TE Connectivity

Product Change Notification: PCN-23-176089

RJ45 JACK INT.MAG. 1Gb LED 1x1 INV

Before change

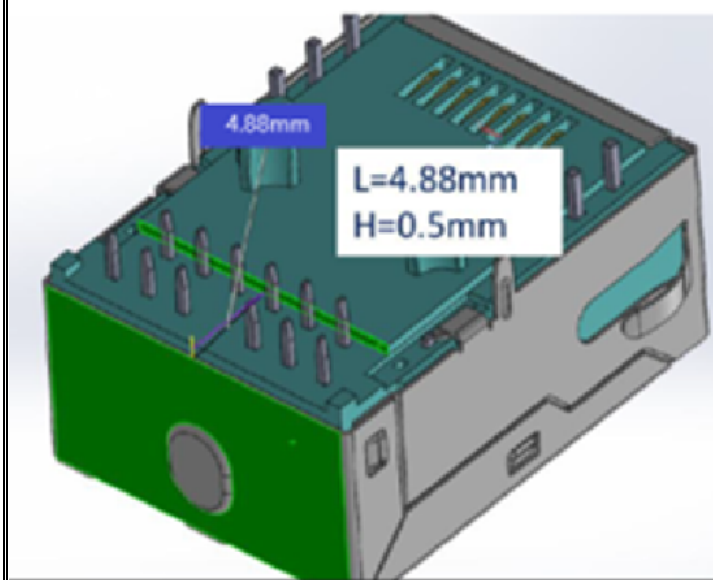
Clearance modification around LED pins.

Improvement for the soldering process.
